# EDEN ESTATE GEOMORPHOLOGY ASSESSMENT

RESPONSE TO RFIS

B25311

| DATE PRINTED     |              | JOB NUMBER                           | REPORT NUMBER |            |
|------------------|--------------|--------------------------------------|---------------|------------|
| PROJECT SUBTITLE |              | Response to RFI's                    |               |            |

Figure 3-1 Channel stability thresholds for velocity at 1% AEP event (post development).

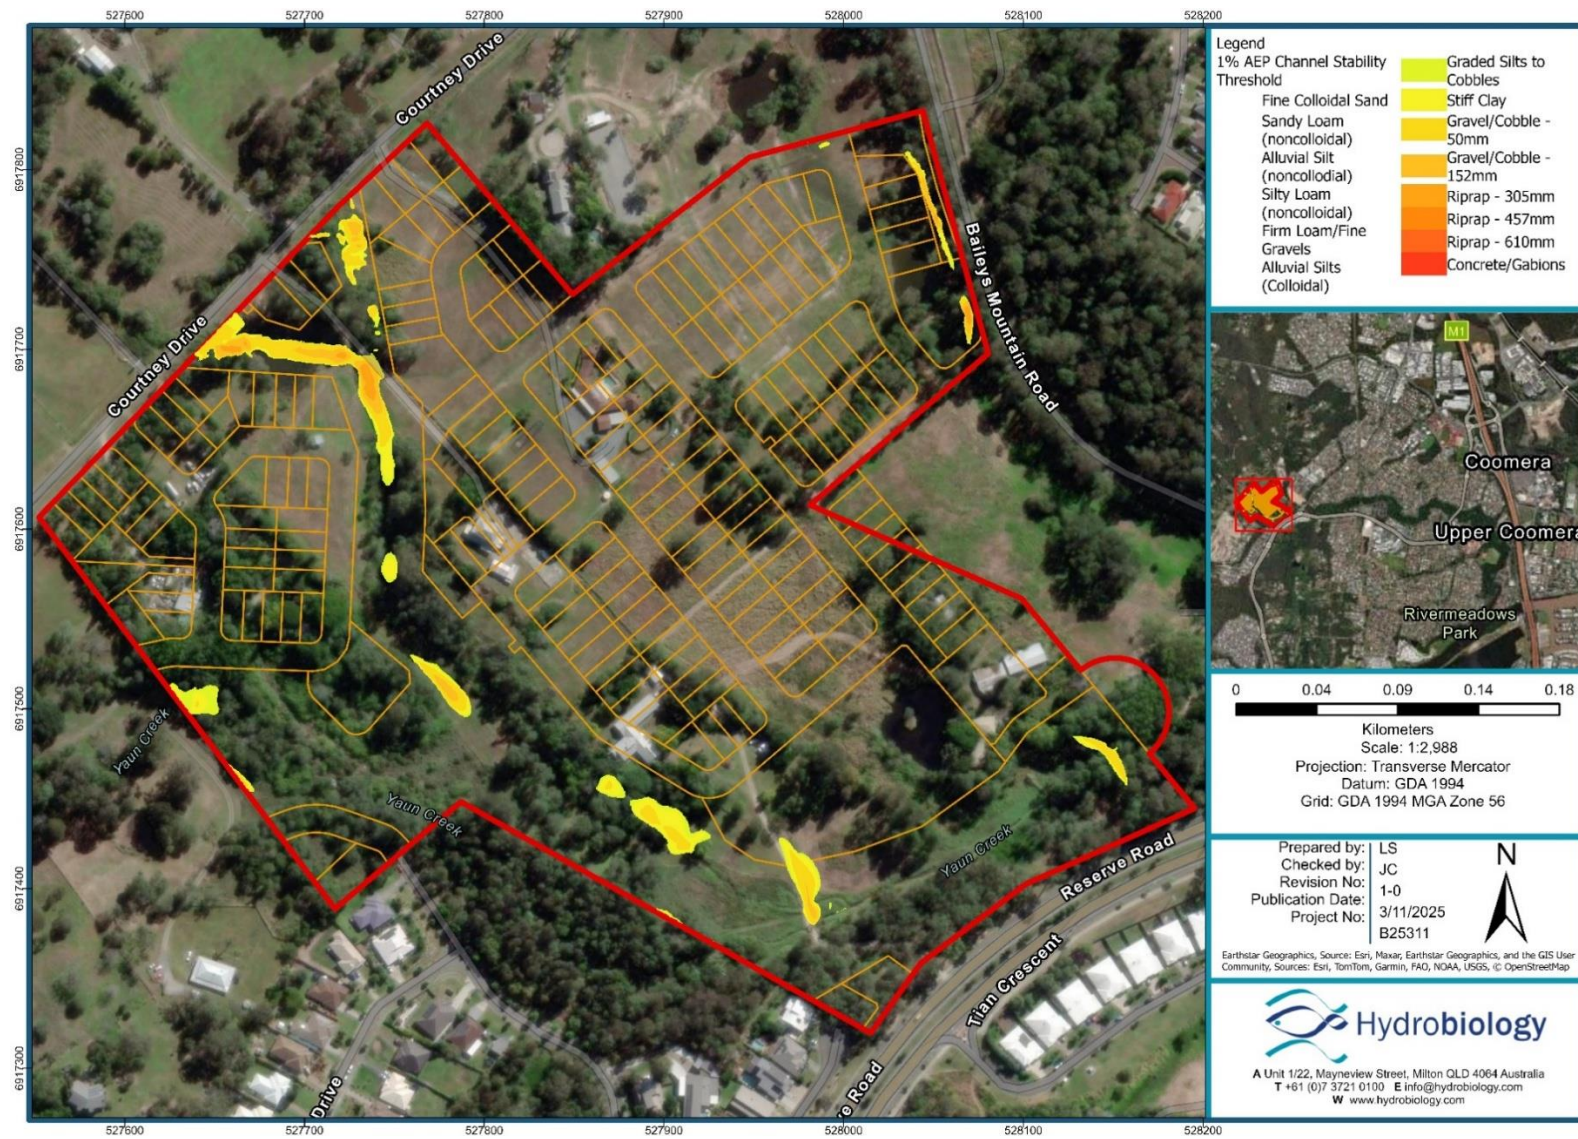
| City of Gold Coast RfI                                                                                                                                                                                                                                                                                                                                                                    | Information Reference                                                                                                                                                                                                                                                                                                                                                                                                                                                                         |
|-------------------------------------------------------------------------------------------------------------------------------------------------------------------------------------------------------------------------------------------------------------------------------------------------------------------------------------------------------------------------------------------|-----------------------------------------------------------------------------------------------------------------------------------------------------------------------------------------------------------------------------------------------------------------------------------------------------------------------------------------------------------------------------------------------------------------------------------------------------------------------------------------------|
| <b>Ensure that the geomorphic/bank stability assessment uses the pre- and post-development velocities obtained from the hydraulic impact assessment for different AEP events for the analysis. Additionally, the hydraulic impact assessment should incorporate suitable roughness coefficient (Manning's n) values for Reaches 1 to 4, in accordance with the geomorphic assessment.</b> | <ul style="list-style-type: none"> <li>See previous Hydrobiology assessment for smaller events (0.5EY and 2% AEP). This report and Section 2.3 covers the 1% AEP design event which naturally ensures stability during the 0.5EY and 2% AEP events.</li> <li>Section 2.4 uses 1% AEP post development BSS hydraulics for assessment.</li> <li>See Section 3.3 for review of Mannings n. Roughness values are to be implemented into the hydraulic model following this assessment.</li> </ul> |

Post-development hydraulic modelling (velocity) indicated that the upstream sections of Reaches 1 and 2 remained erosion hotspots, with additional hotspot zones downstream (Figure 3-1). During the 1% AEP event, modelled flow velocities exceed permissible stability thresholds at these locations. Accordingly, these sections are expected to experience ongoing hydraulic forcing under both low- and high-flow conditions, sustaining a heightened risk of bank retreat and bed instability. These sections are to be addressed through riprap mitigation (Figure 3-6).

Figure 3-6 Proposed armouring locations are shown with turquoise circle (conceptual)

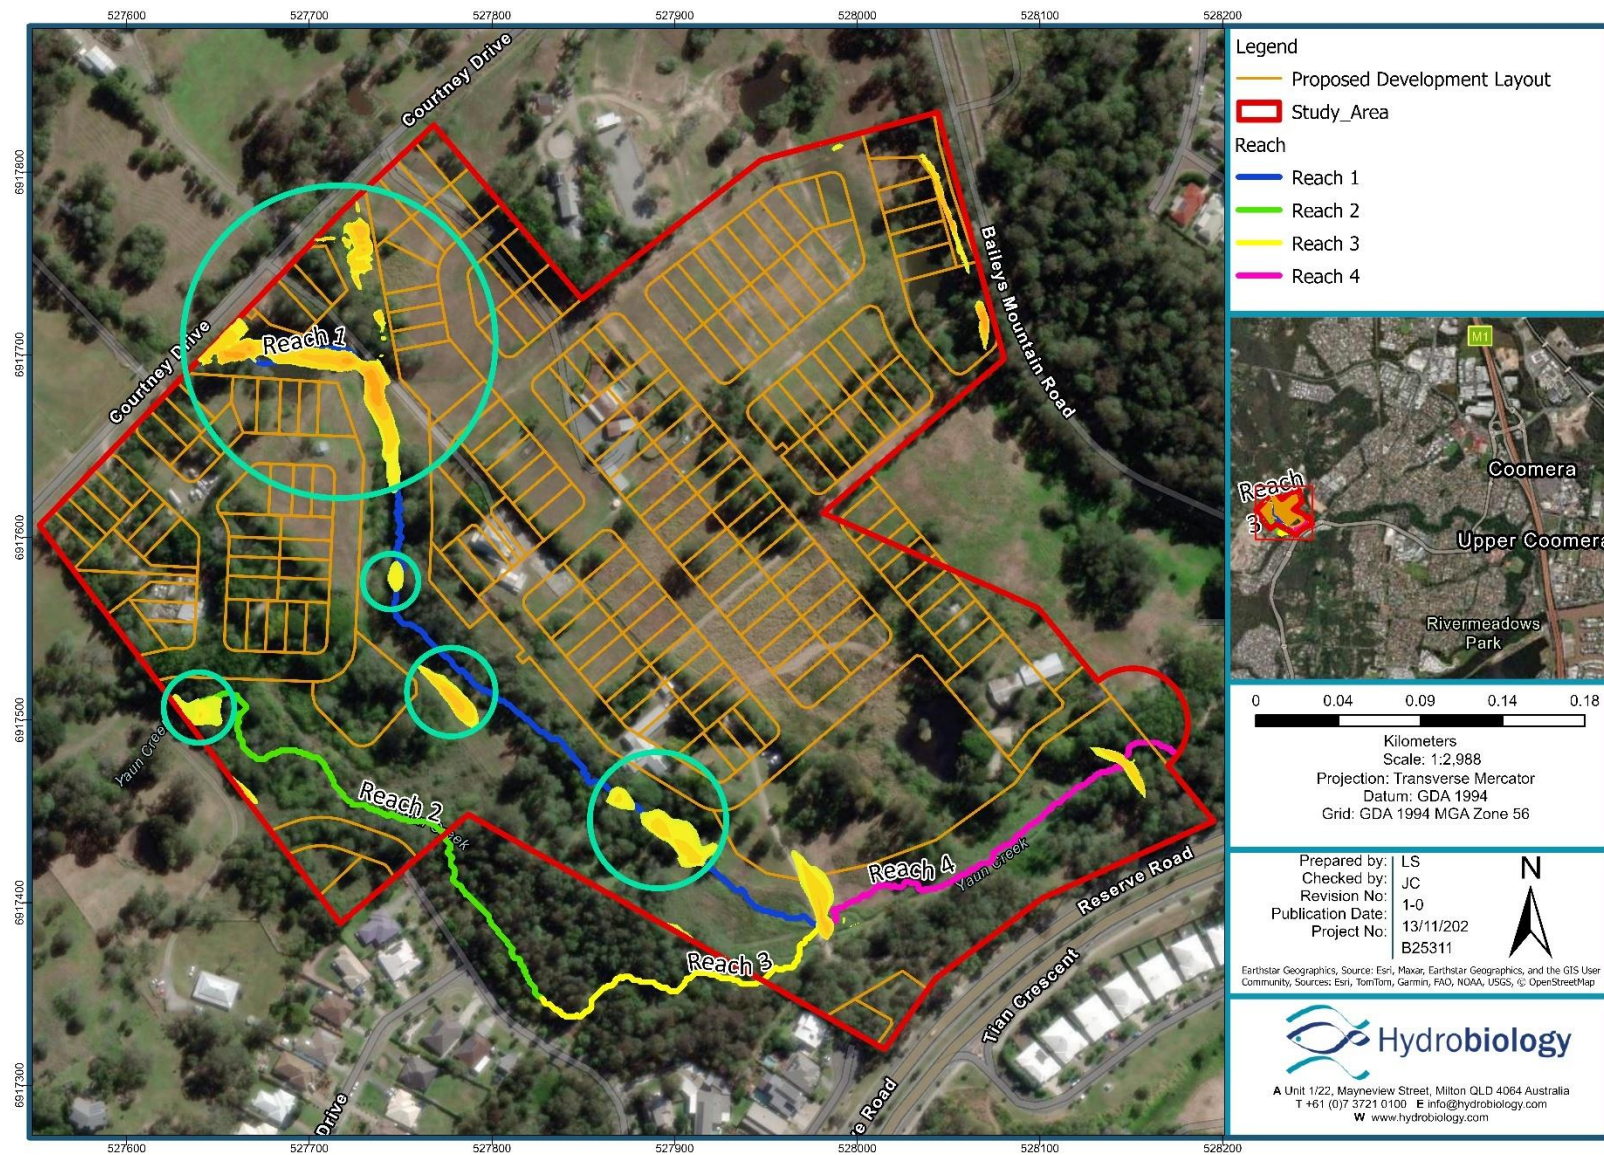
| City of Gold Coast RfI                                                                                                                                                                                                                                                                                                                                                                    | Information Reference                                                                                                                                                                                                                                                                                                                                                                                                                                                                         |
|-------------------------------------------------------------------------------------------------------------------------------------------------------------------------------------------------------------------------------------------------------------------------------------------------------------------------------------------------------------------------------------------|-----------------------------------------------------------------------------------------------------------------------------------------------------------------------------------------------------------------------------------------------------------------------------------------------------------------------------------------------------------------------------------------------------------------------------------------------------------------------------------------------|
| <b>Map (conceptually) the sections of Reach 1 and Reach 2 that are required for armouring (rip rap).</b>                                                                                                                                                                                                                                                                                  | <ul style="list-style-type: none"> <li>See Section 3.4 for hydraulic/geomorphic risk areas and Section 3.6 for conceptual map / conceptual designs</li> </ul>                                                                                                                                                                                                                                                                                                                                 |
| <b>Where changes are made to the existing development – provide an amended (conceptual) map of required armouring for site waterways</b>                                                                                                                                                                                                                                                  | <ul style="list-style-type: none"> <li>No changes to existing development by the developer were noted.</li> <li>See Section 3.6 for conceptual map and conceptual designs.</li> </ul>                                                                                                                                                                                                                                                                                                         |

As per the additional RfI's submitted by City of Gold Coast, Figure 3-6 shows conceptual areas required to be protected due to the level of risk defined by the geomorphic assessment. The location at the interface of Reach 1, 3, and 4 which is not circled is assumed to be addressed through separate creek crossing design. If this is not part of the intentions of the developer to address through separate design this should also be protected to prevent erosion downstream of the existing crossing.

Figure 3-7: Cross Sectional General Design Principals

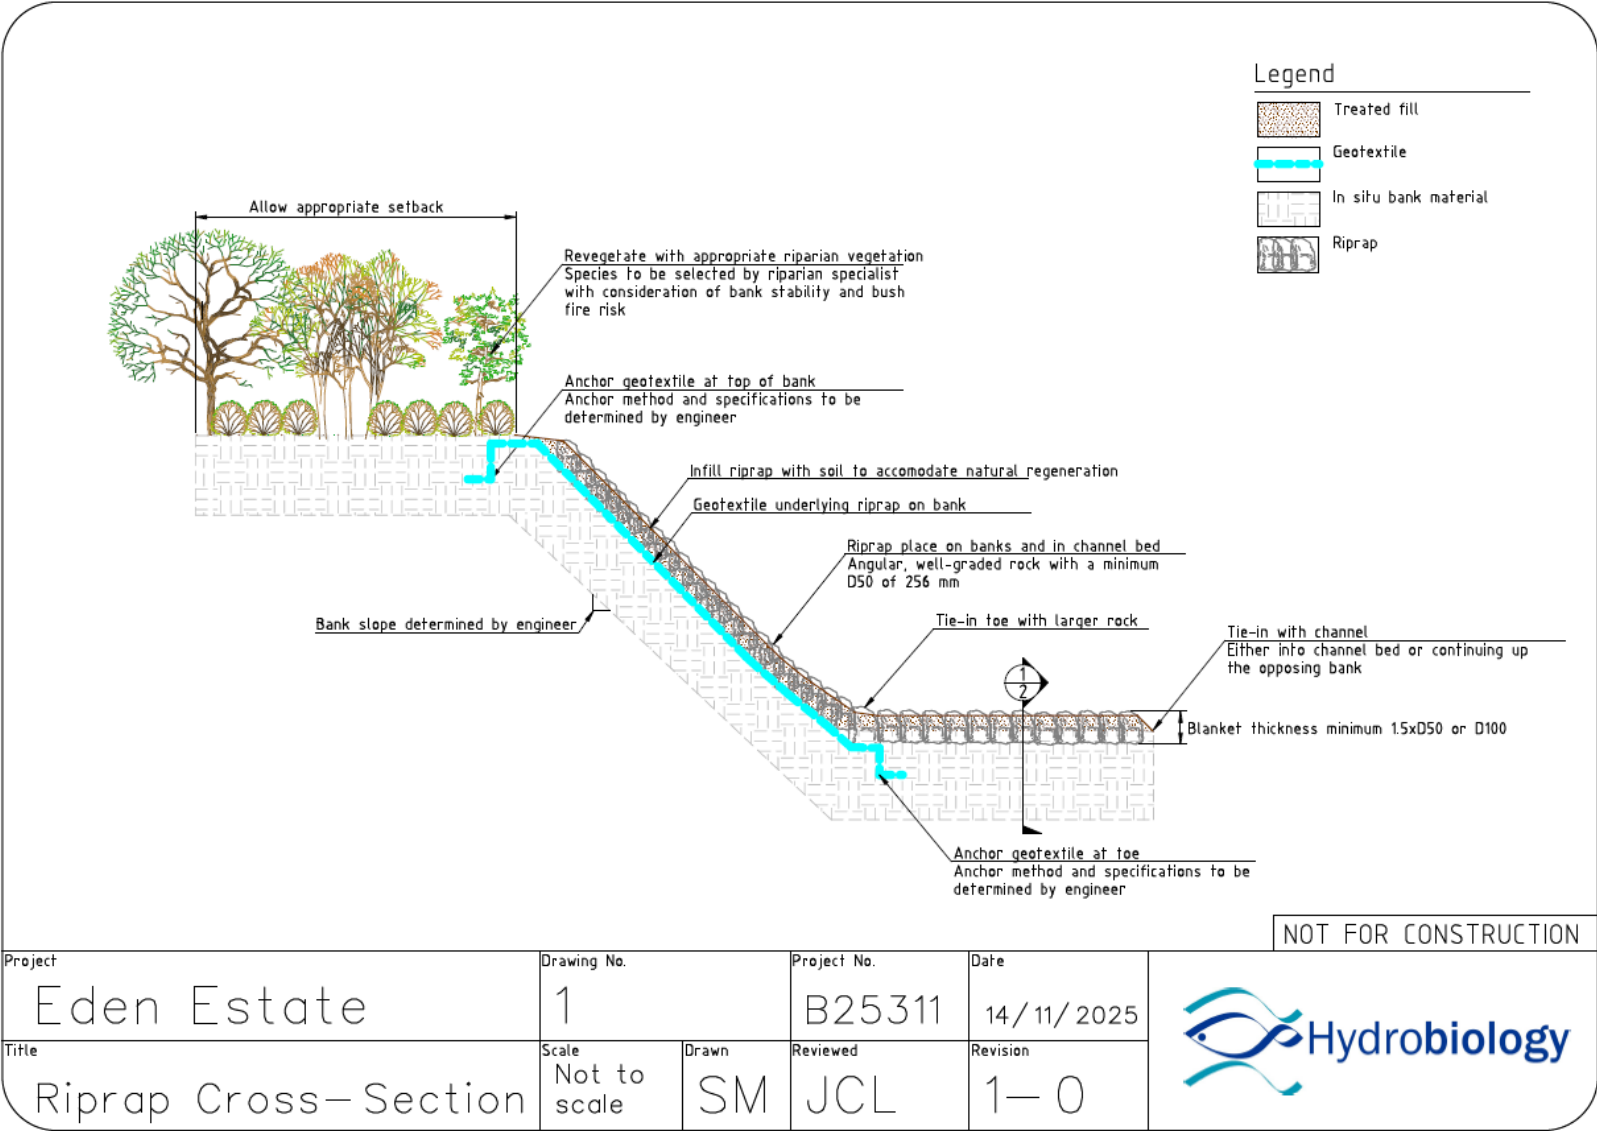
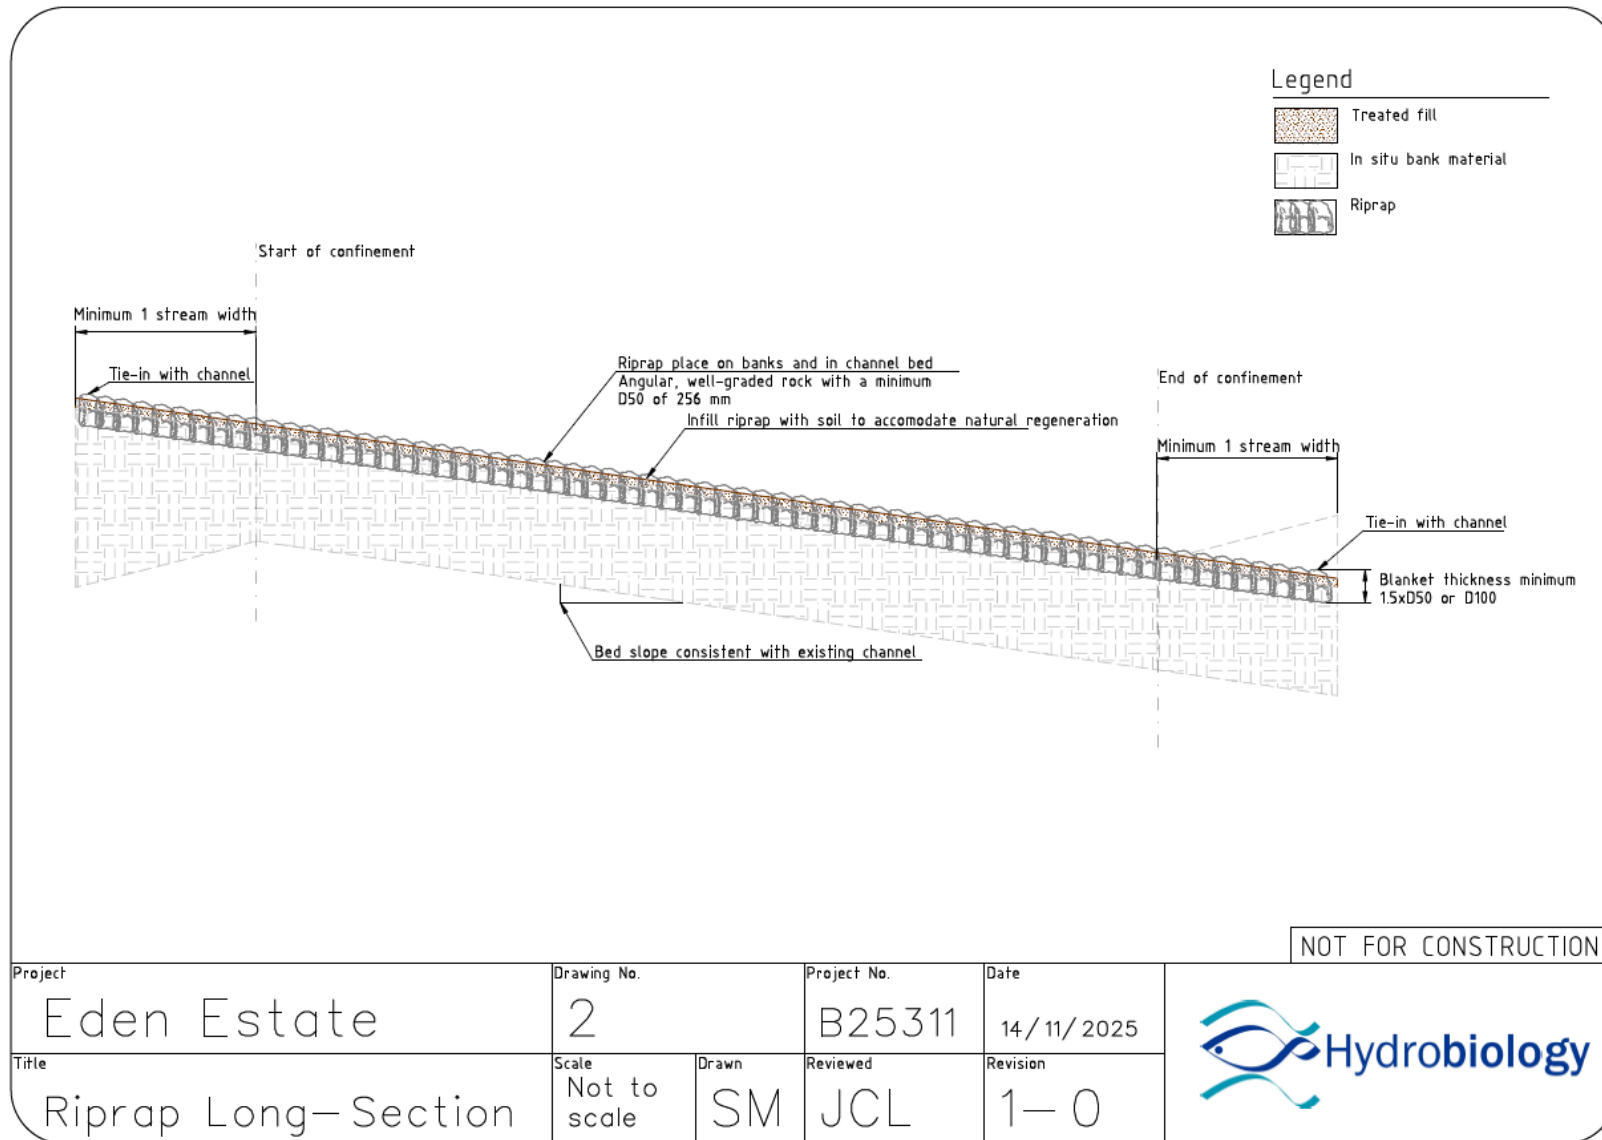
| City of Gold Coast RfI                                                                                                                                                                                                                                                                                                                                                                    | Information Reference                                                                                                                                                                                                                                                                                                                                                                                                                                                                         |
|-------------------------------------------------------------------------------------------------------------------------------------------------------------------------------------------------------------------------------------------------------------------------------------------------------------------------------------------------------------------------------------------|-----------------------------------------------------------------------------------------------------------------------------------------------------------------------------------------------------------------------------------------------------------------------------------------------------------------------------------------------------------------------------------------------------------------------------------------------------------------------------------------------|
| <b>Where significant areas of rock armouring are proposed, ecological outcomes are requested to be considered in the design. This can include mimicking natural features such as the use of different rock sizes and appropriately sized and placed logs to provide a greater range of micro habitats for instream organisms and riparian fauna.</b>                                      | <ul style="list-style-type: none"> <li>See Section 3.2 for proposed ecological outcomes.</li> <li>See Section 3.6 for conceptual designs.</li> </ul>                                                                                                                                                                                                                                                                                                                                          |

Figure 3-7 and Figure 3-8 presents a general, not for construction conceptual approach to waterway design which implements recommendations set out in Section 3.2 as a guide for the design engineer to use during subsequent detailed design phases. These conceptual designs are intended to be implemented at locations circled in Figure 3-6. Location specific detailed designs should be produced utilising these conceptual designs at later stages.
